LAKE • GEORGE
WATERKEEPER®

Re: Gull Bay Road Extension Culvert

Culvert Outlet:

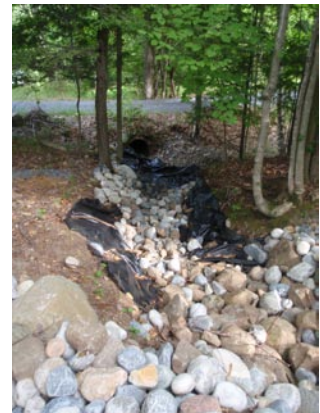
The (4) main channel culverts discharge to the south to a partial stone and earthen channel with filter fabric. Construction is incomplete and inadequate.

- The stone outlet protection appears to be incomplete. This will fail to adequately reduce outlet velocities and will result in the potential for erosion and sedimentation.
- The lower portion of the earthen channel is unprotected resulting in the potential for erosion and sedimentation.
- The outlet channel does not appear to be completely excavated to allow free discharge. This will result in ponding and further potential of erosion.
